Title - Sujet Palace Grand Theatre Foundation Rep	
Solicitation No. - N° de l'invitation EZ899-152418/A	Amendment No. - N° modif. 012
Client Reference No. - N° de référence du client	Date 2015-07-29
GETS Reference No. - N° de référence de SEAG PW-\$PWY-022-7522	
File No. - N° de dossier PWY-5-38030 (022)	CCC No./N° CCC - FMS No./N° VME
Solicitation Closes - L'invitation prend fin at - à 02:00 PM on - le 2015-08-04	Time Zone Fuseau horaire Pacific Daylight Saving Time PDT
F.O.B. - F.A.B. Plant-Usine: <input type="checkbox"/> Destination: <input checked="" type="checkbox"/> Other-Autre: <input type="checkbox"/>	
Address Enquiries to: - Adresser toutes questions à: Arthur (PWY), Carolyn	Buyer Id - Id de l'acheteur pwy022
Telephone No. - N° de téléphone (604) 775-6667 ()	FAX No. - N° de FAX (604) 775-6633
Destination - of Goods, Services, and Construction: Destination - des biens, services et construction: Parks Canada - Palace Grand Theatre - Dawson City, YT

Palace Grand Theatre Foundation Replacement
Palace Grand Theatre, Dawson City, YT

Project title/Titre du projet PALACE GRAND THEATRE FOUNDATION REPLACEMENT DAWSON CITY YUKON TERRITORY	Drawing title/Titre du dessin TYP. DETAIL FO

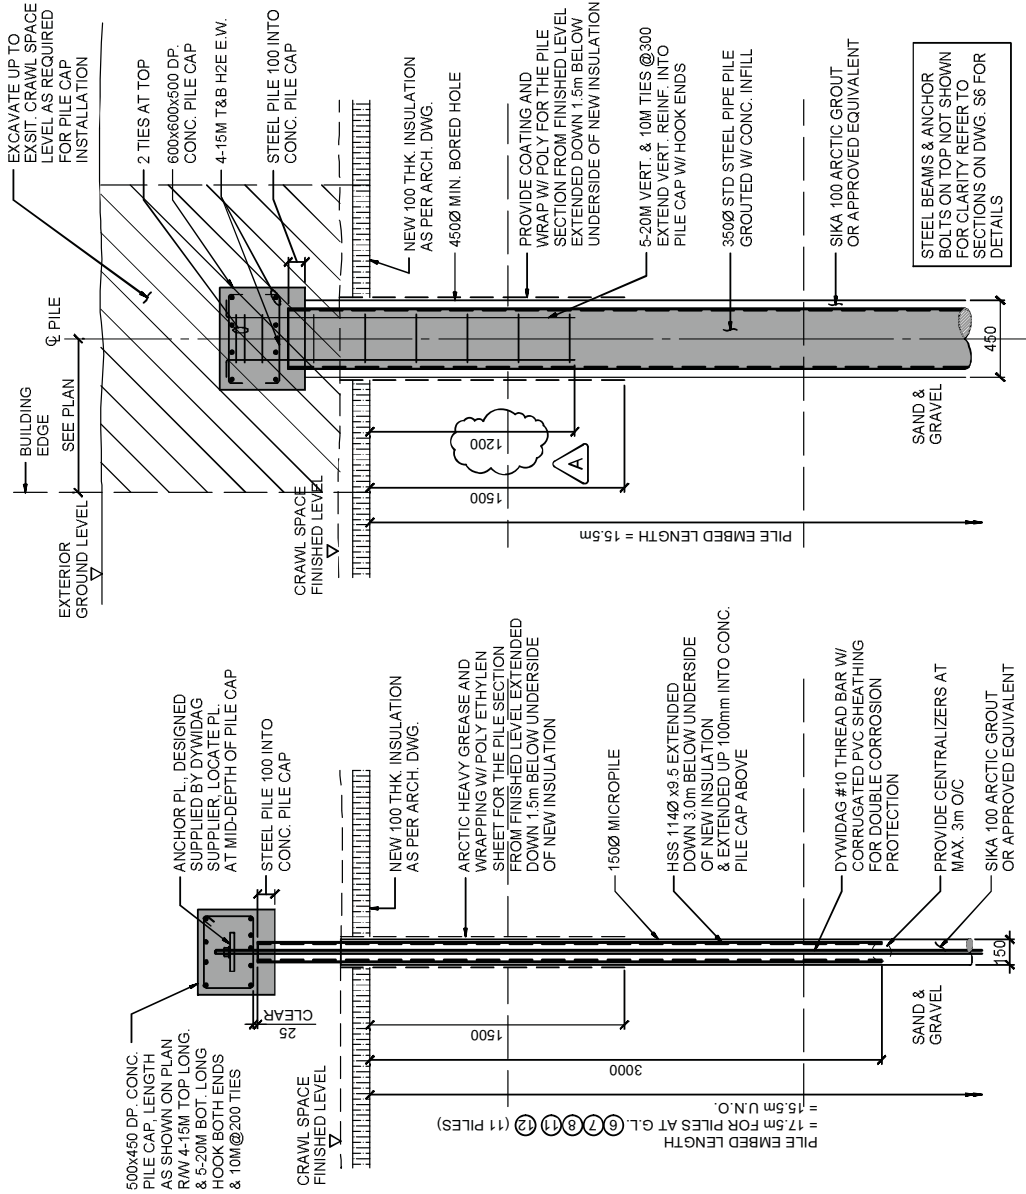
- .1 **Clarify** the rebar cage depth for the steel pipe pile as per attached addendum sheet AD-S01 Revision A.

TYPICAL DETAIL FOR EXTERIOR
BORED/DRILLED STEEL PIPE PILE

TYPICAL DETAIL FOR INTERIOR MICROPILE
